LAND USE TYPE III APPLICATION

1010 SE ASH STREET

LU 20-12348 HR

April 24, 2020

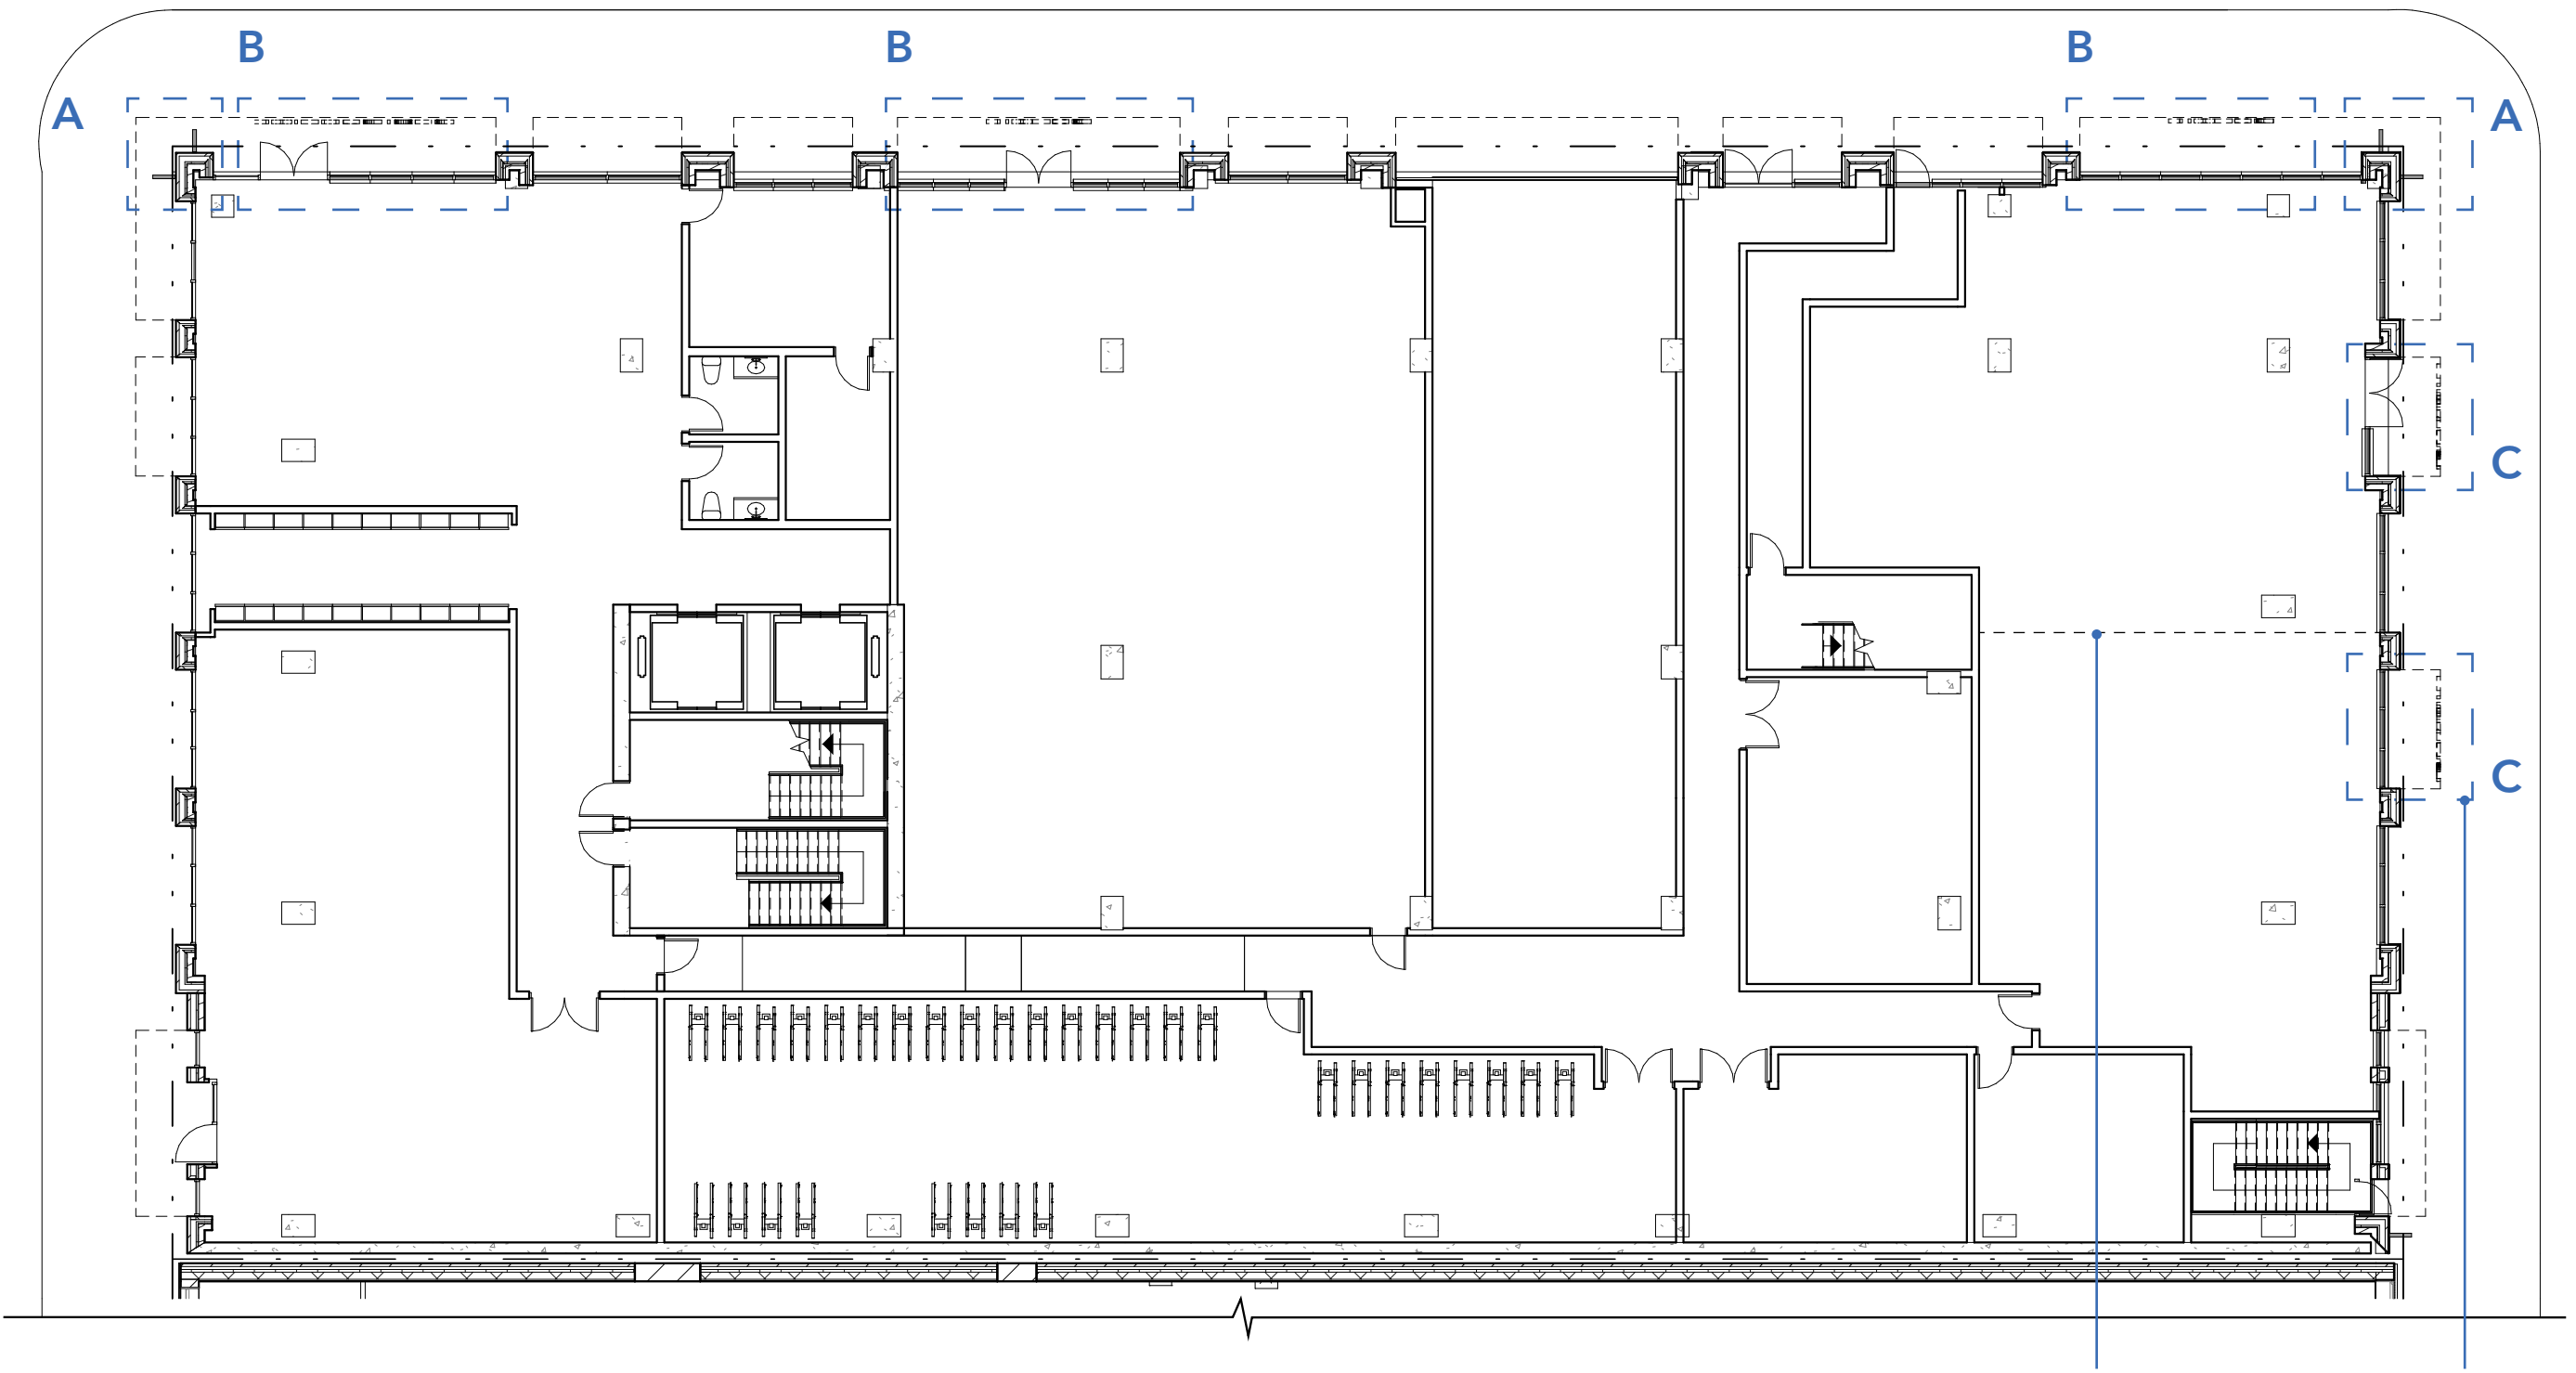
- Please provide accurate calculation on the percentage of glazing up to 60’-0” above grade as it relates to the Bird Safe Glazing standard; it is possible that if only the glazing is counted, the proposal may not meet the 30% threshold and bird safe glazing would not be required.

Response: Refer to Glazing Percentage Calculation exhibit C.50

FACADE MATERIALS | South Elevation

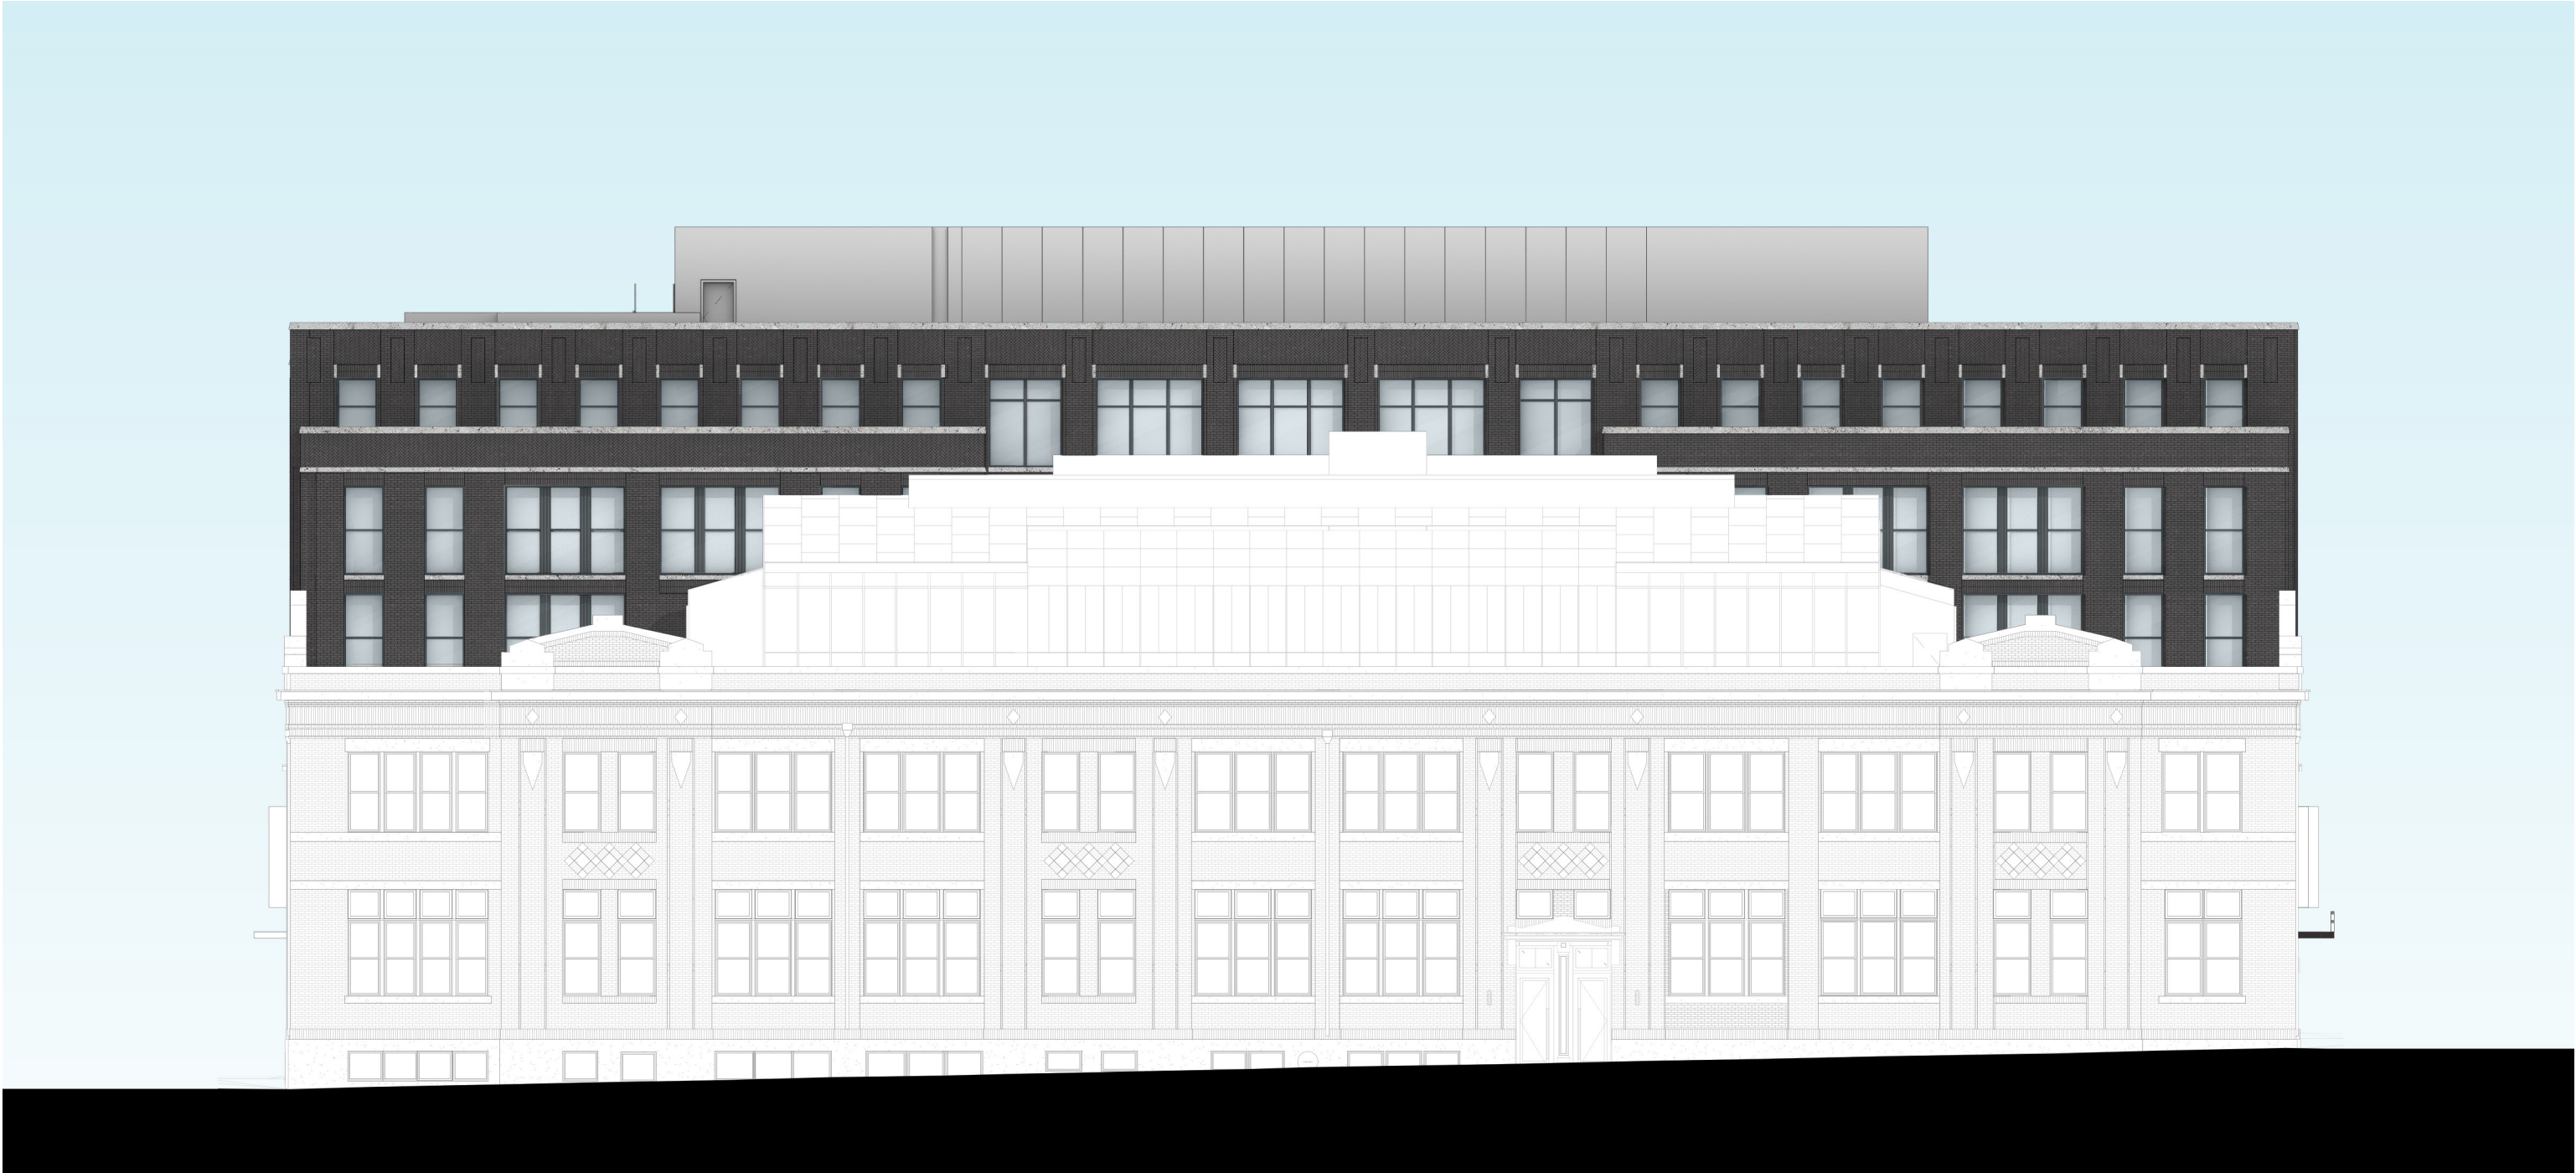
If portions of the building are intended to be constructed along the property line, the elevations should be clear that any windows proposed are not operable windows with vision glazing; alternatively, these facades should be shown as brick for a more authentic expression. As noted above, the Commission was not supportive of 5-story volumes adjacent to the Troy Laundry building and these volumes should be reduced in height.

Response: The south elevation is expressed with brick detailing found on other facades of the architecture, any spandrel windows located on this elevation are tagged and indicated in the material legend. Windows will be minimally visible based on the revised Troy Laundry Building massing and units will receive all natural light and vent through the courtyard and east and west facades. Refer to South Elevation exhibit C.35.

UTILITIES | Plan

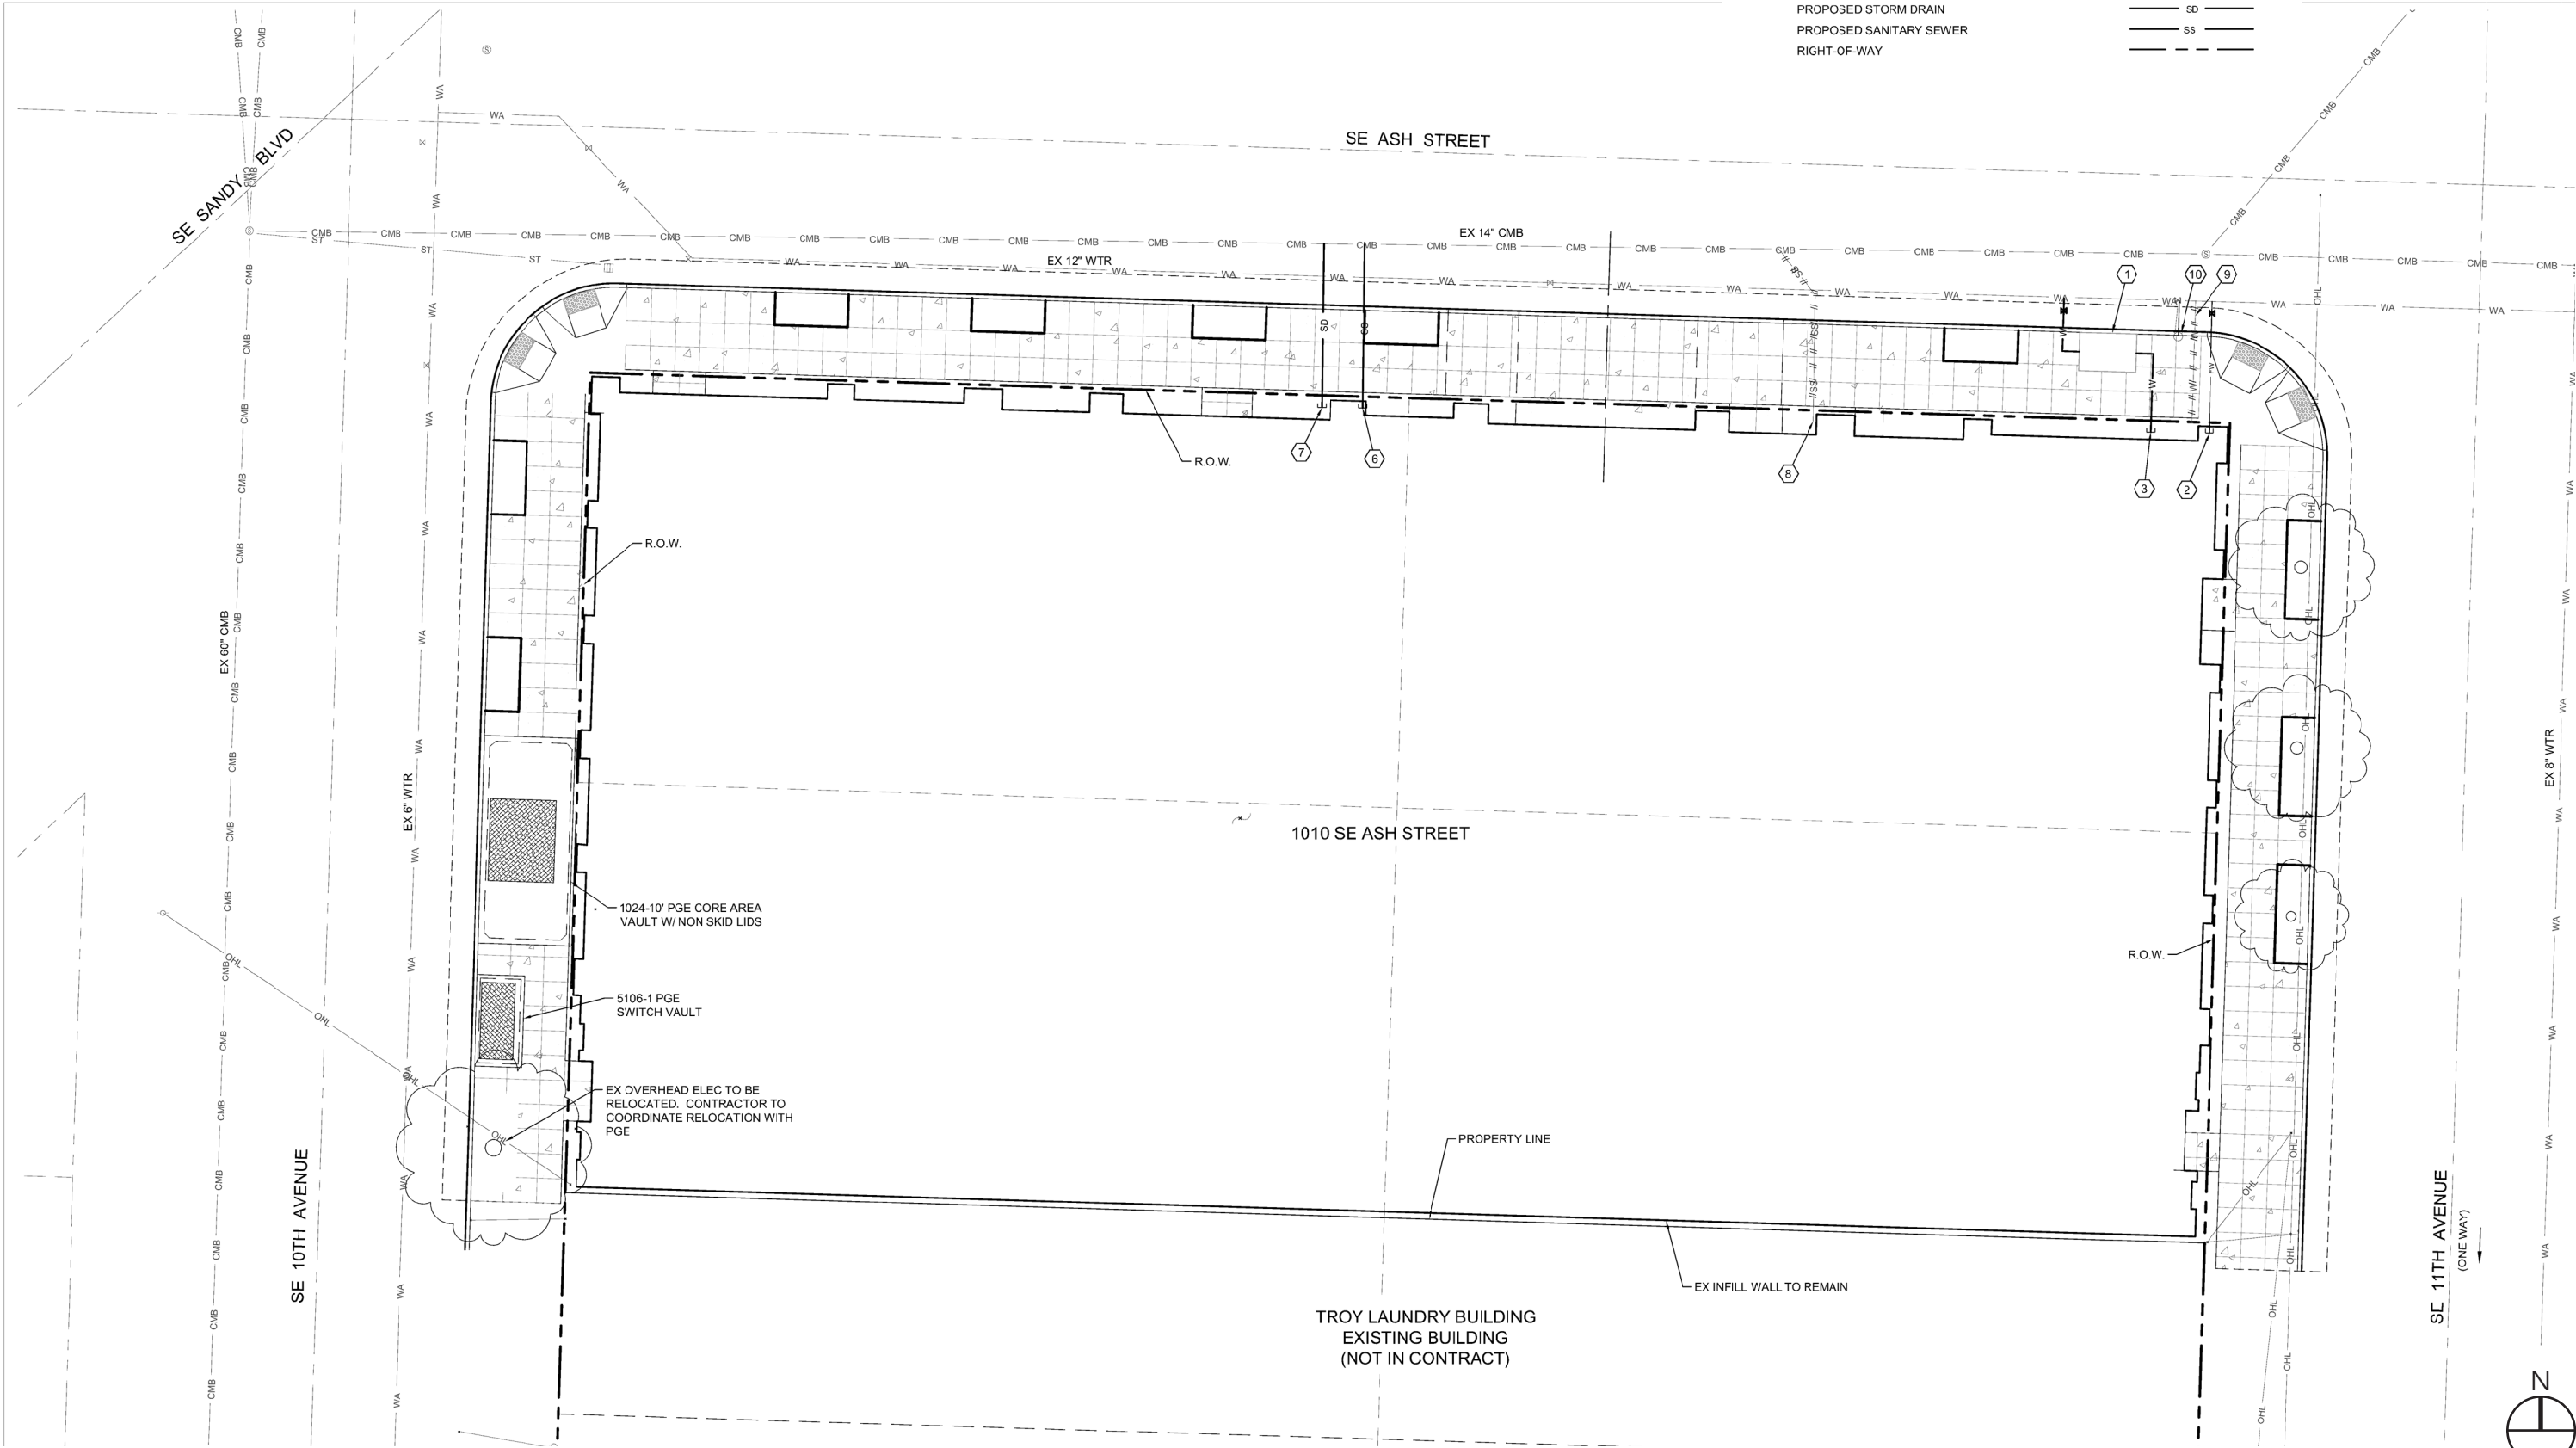
The submitted utility plan does not include information on a transformer vault.

The existing conditions plan on sheet C69 shows an overhead line leading to a point near the southern property line along SE 10th Ave. The utility plan on sheet C68 shows that same overhead line. Please confirm how electric power will be provided to the project. Given the size of the building, it seems likely that a transformer vault will be needed in the right-of-way. If this is the case, a utility plan must be submitted for review by the PBOT utility group. (Administrative Rule TRN 8.13 available at <https://www.portlandoregon.gov/citycode/article/622898>.) *Any Utility Vault in the right-of-way must be conceptually approved prior to PBOT supporting the land use review. Please submit the information sooner than later. The PBOT Utility Permitting group is a small group who cannot expedite reviews.* Please see the end of this document for detailed information on the submittal requirements.

Response: Refer to revised Utility Plan exhibit C.87. Vault application to be submitted following revised Land Use Type III application.
